Remarks

Figure 1 has been amended as follows:

FIG. 6

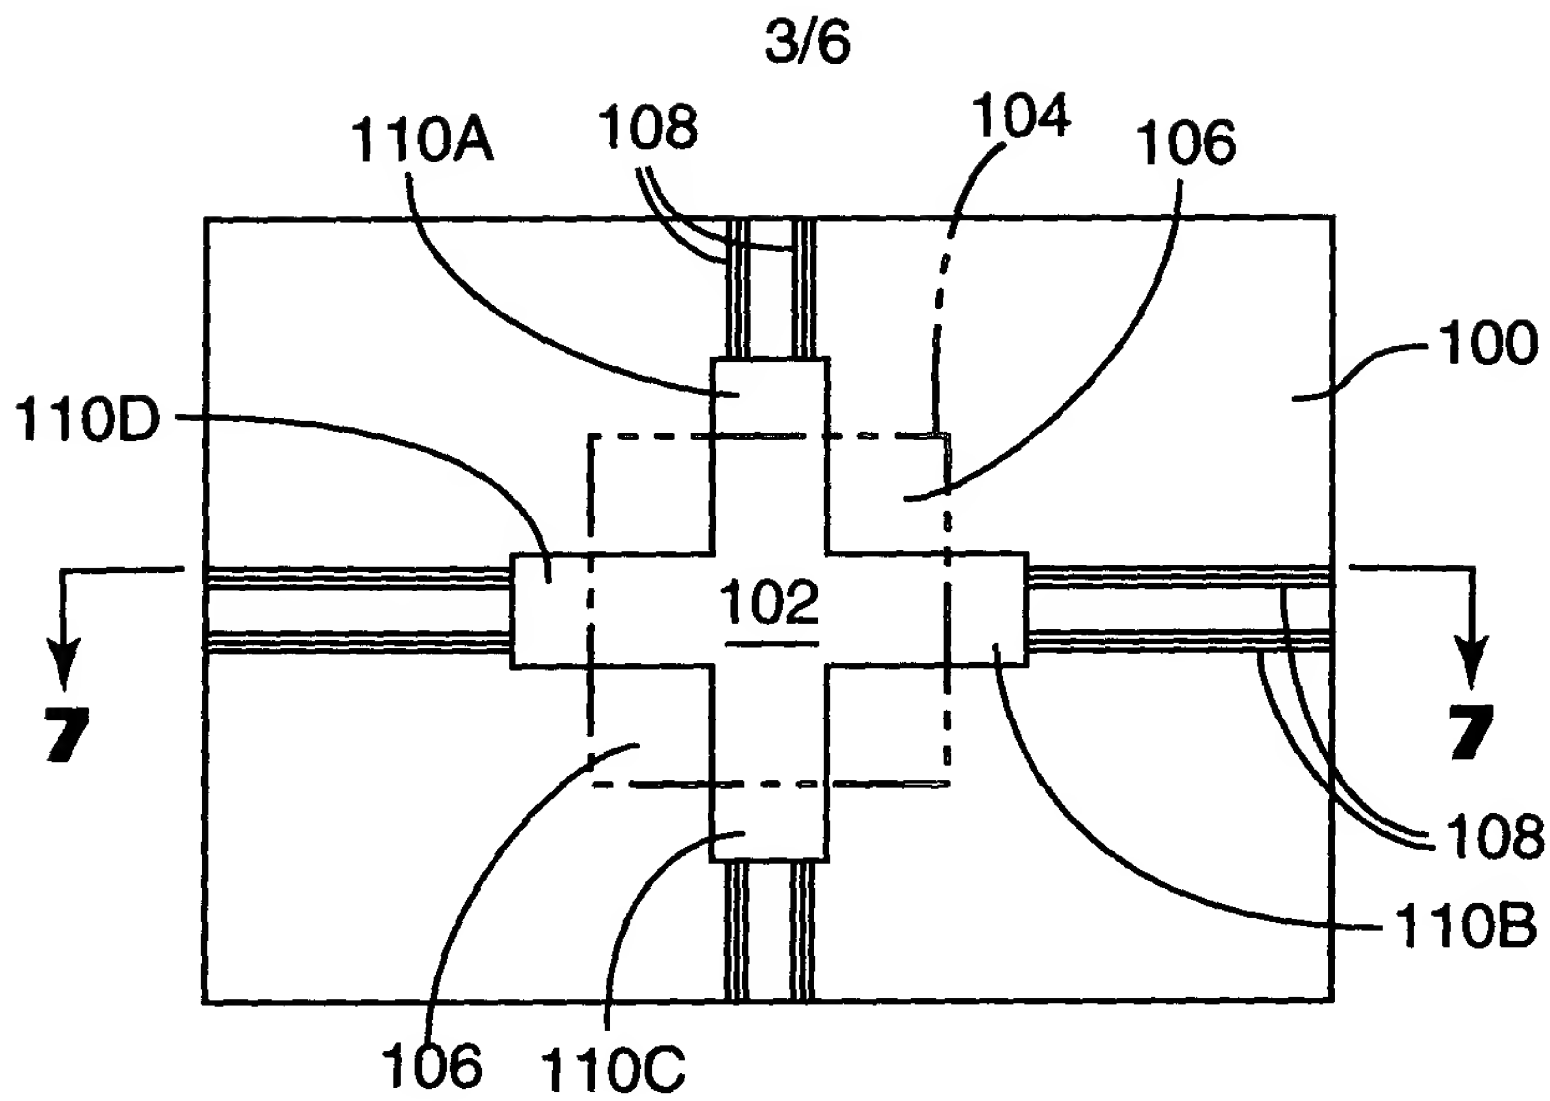
The line format for the die (104) has been changed to "phantom." Support for this amendment is found at page 12, lines 28-29.

FIG. 7

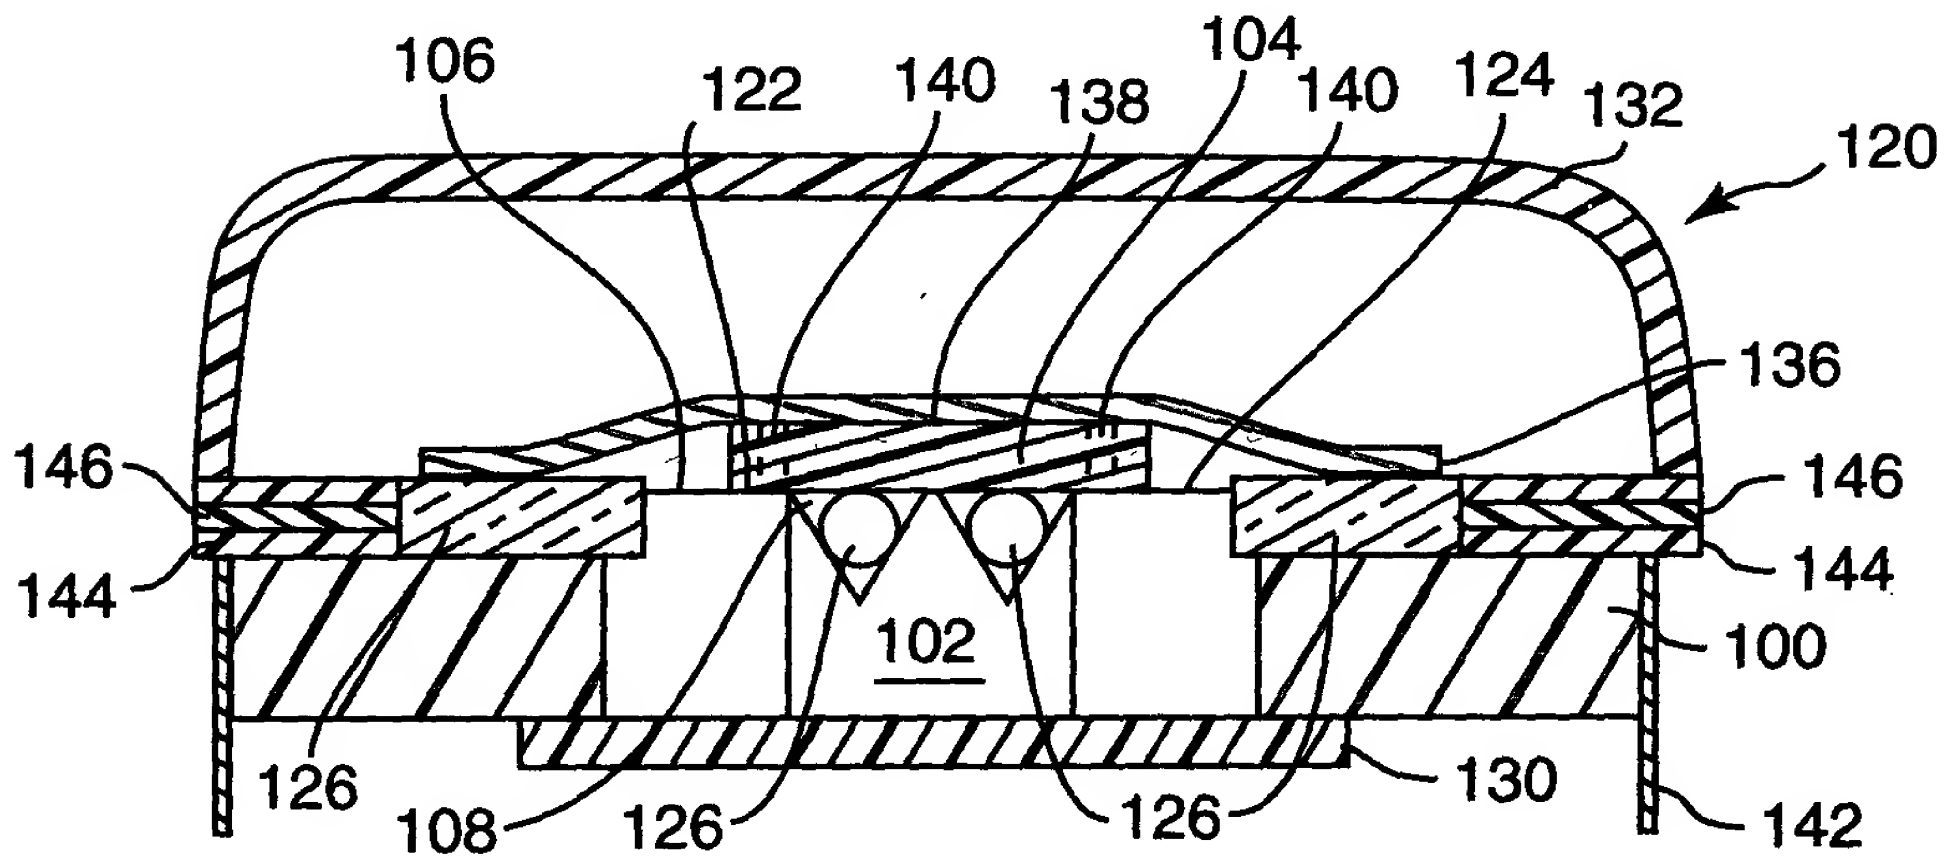
The cross-hatching of the package frame (**100**) has been changed to indicate an insulative part. Support for this amendment is found at page 7, line 24 - page 8, line 12.

The cross-hatching has been removed from the aperture (**102**). Support for this amendment is found at page 10, lines 20-25.

The cross-hatching for the flex circuit (**136**) has been changed to indicate a conductive material. Support for this amendment is found at page 13, lines 22-29.

The cross-hatching has been removed from the lenses (**126**) shown in end-view. Support for this amendment is found at page 2, lines 27-31.

FIG. 8

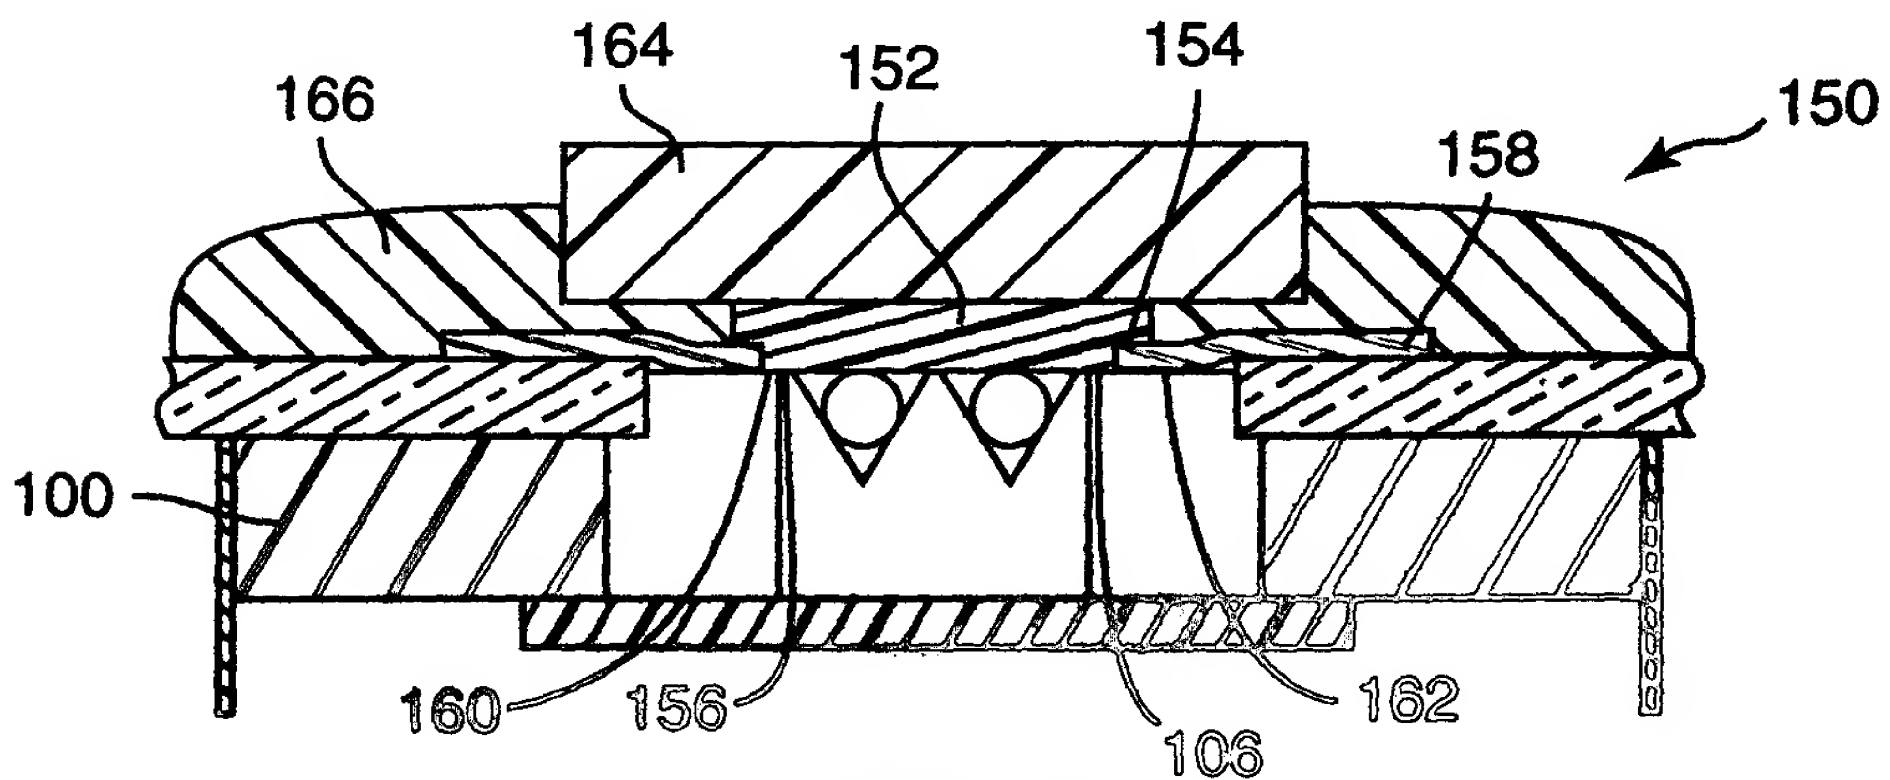
The cross-hatching of the package frame (**100**) has been changed to indicate an insulative part. Support for this amendment is found at page 7, line 24 - page 8, line 12.

The cross-hatching has been removed from the aperture. Support for this amendment is found at page 10, lines 20-25.

The cross-hatching for the flex circuit (**158**) has been changed to indicate a conductive material. Support for this amendment is found at page 14, lines 1-3.

The cross-hatching has been removed from the lenses shown in end-view. Support for this amendment is found at page 2, lines 27-31.

FIG. 10

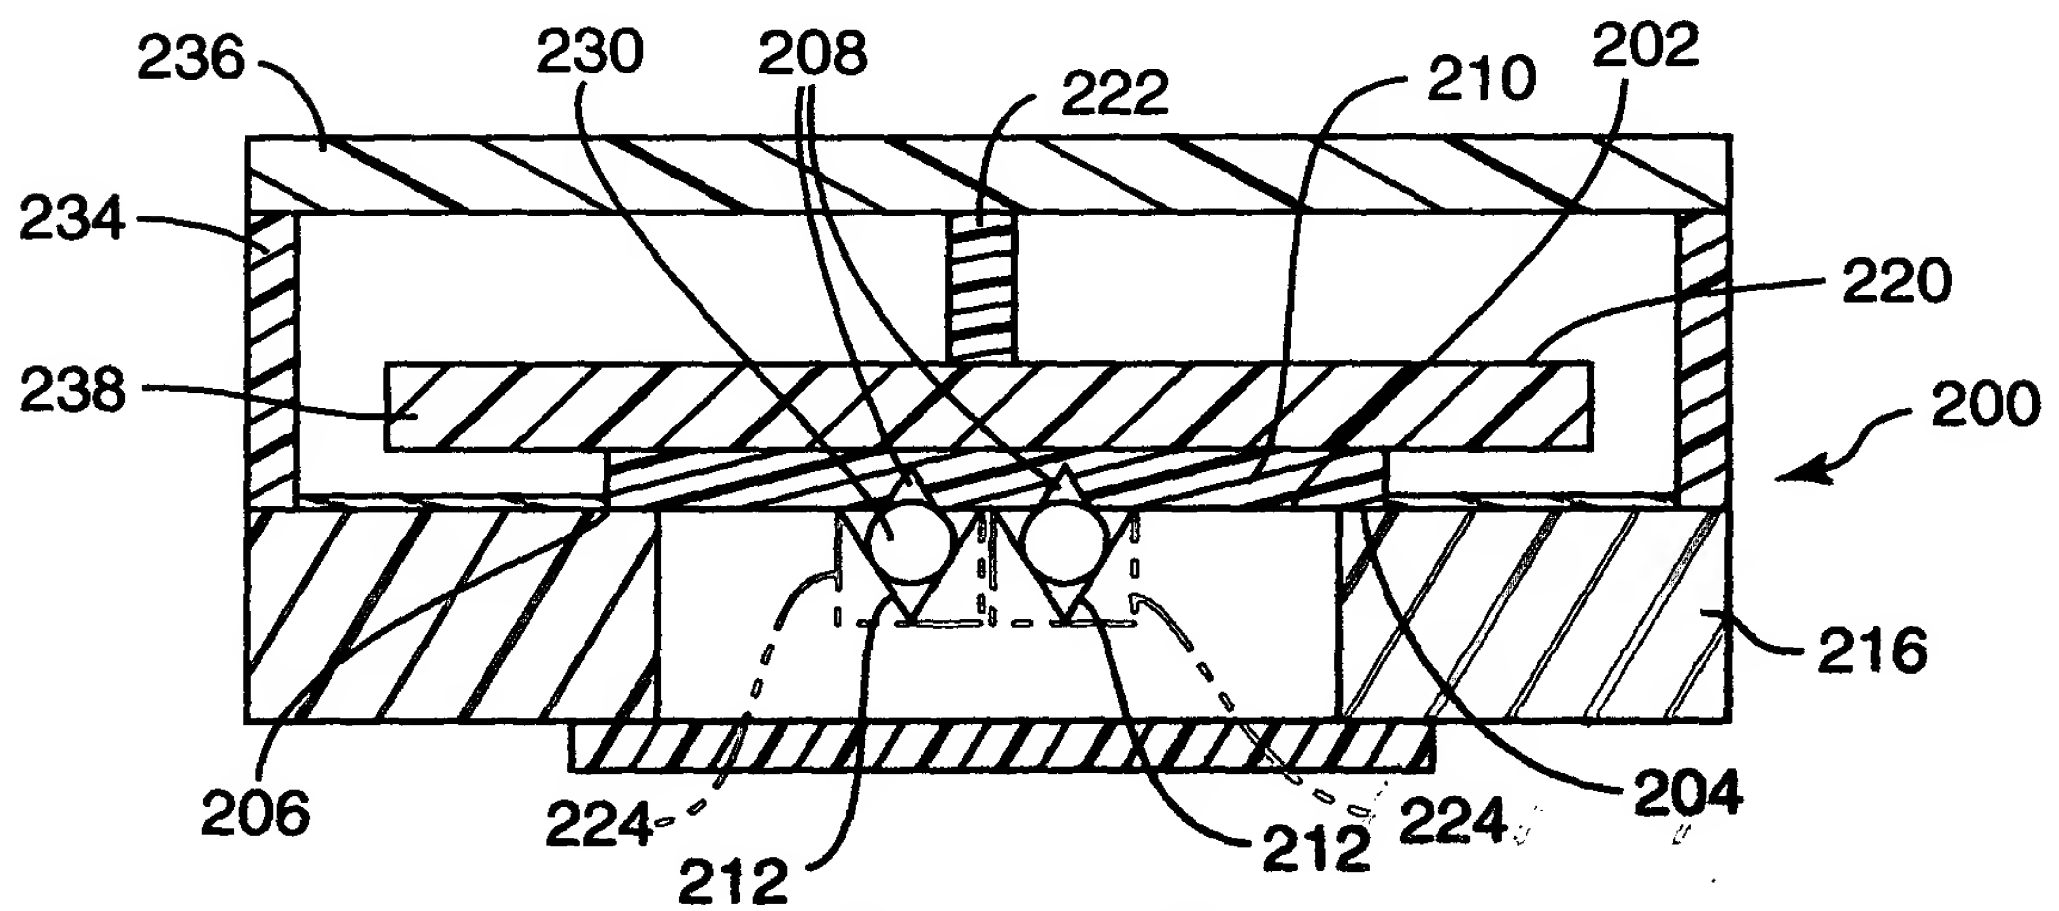
The cross-hatching of the package frame (**216**) has been changed to indicate an insulative part. Support for this amendment is found at page 7, line 24 - page 8, line 12.

The cross-hatching has been removed from the aperture. Support for this amendment is found at page 10, lines 20-25.

The cross-hatching for the flex circuit has been changed to indicate a conductive material. Support for this amendment is found at, e.g., page 14, lines 1-3.

The line format for optical micro-mechanical devices (**224**) has been changed to "phantom." Support for this amendment is found at page 8, lines 20-21.

The cross-hatching has been removed from the lenses (**230**) shown in end-view. Support for this amendment is found at page 2, lines 27-31.

FIG. 12

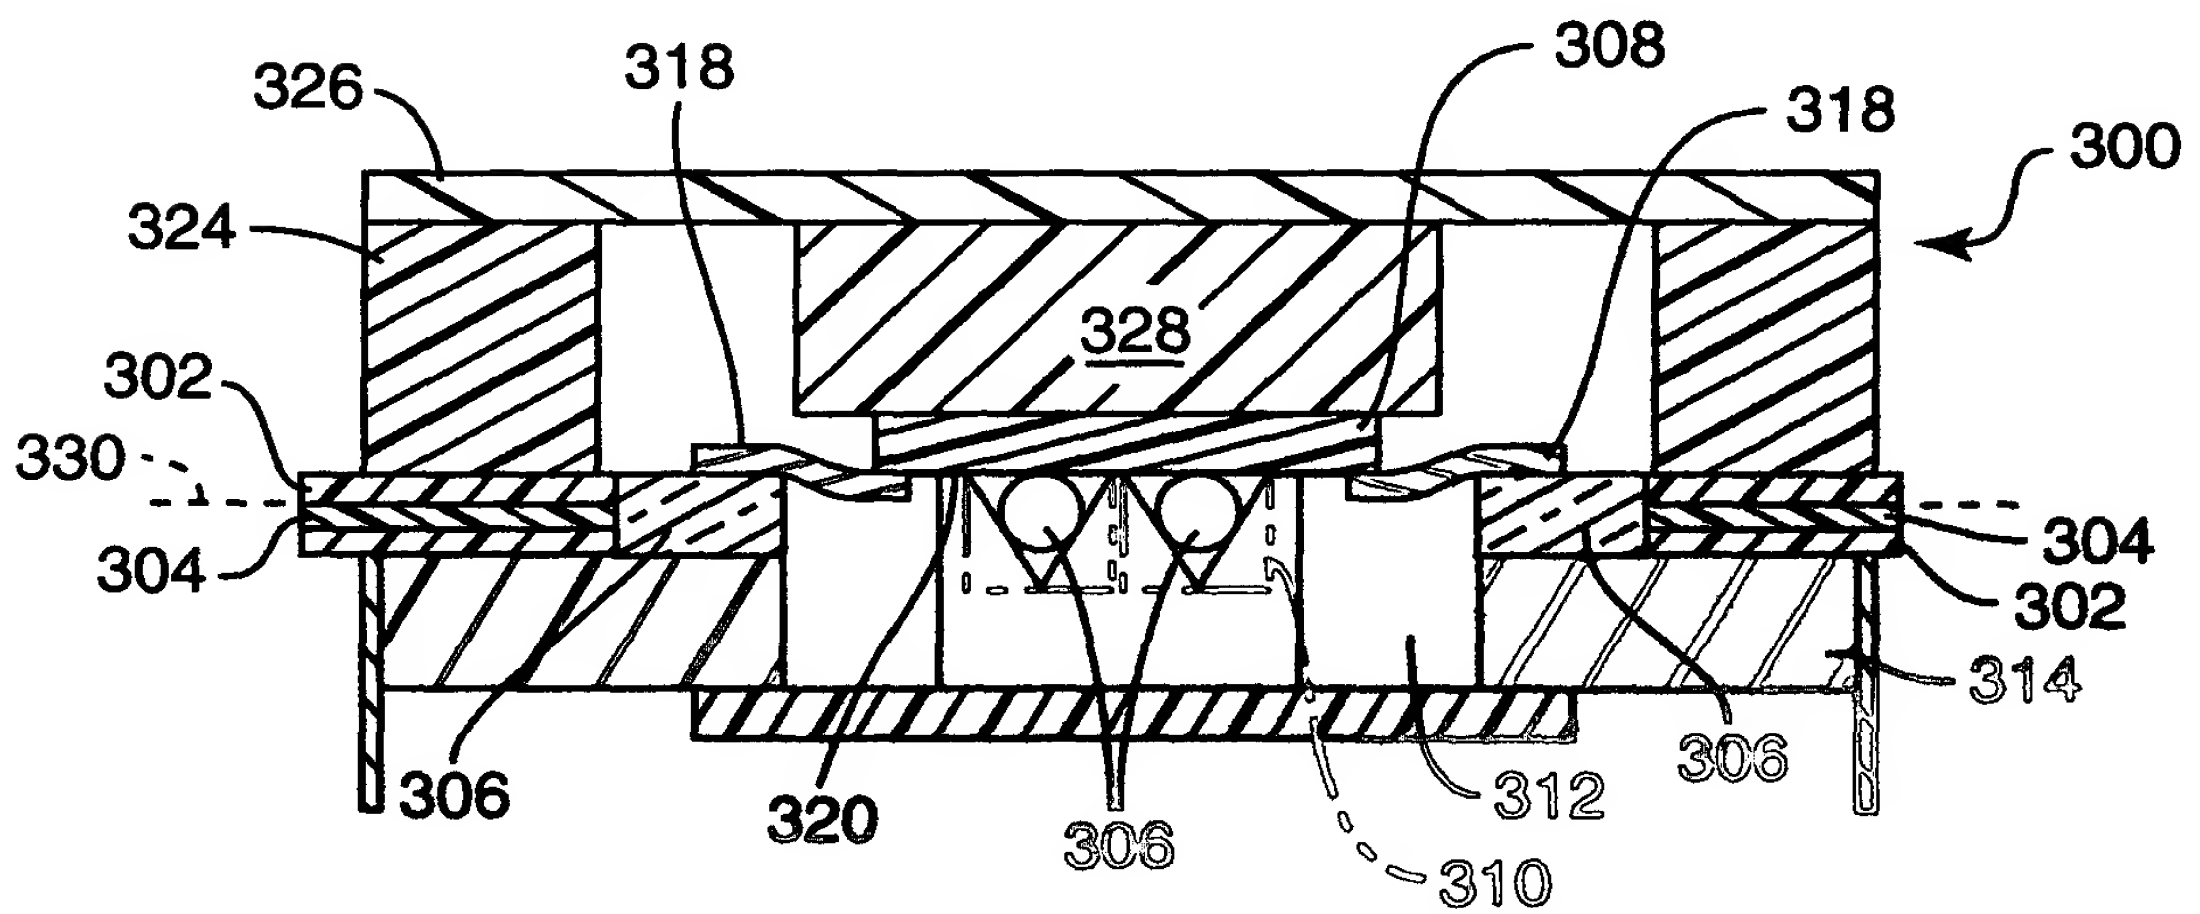
The cross-hatching of the package frame (314) has been changed to indicate an insulative part. Support for this amendment is found at page 7, line 24 - page 8, line 12.

The cross-hatching has been removed from the aperture (312). Support for this amendment is found at page 10, lines 20-25.

The line format for optical micro-mechanical devices (310) has been changed to "phantom." Support for this amendment is found at page 8, lines 20-21.

The cross-hatching for the flex circuit (318) has been changed to indicate a conductive material. Support for this amendment is found at page 15, lines 15-18.

The cross-hatching has been removed from the lenses (306) shown in end-view. Support for this amendment is found at page 2, lines 27-31.
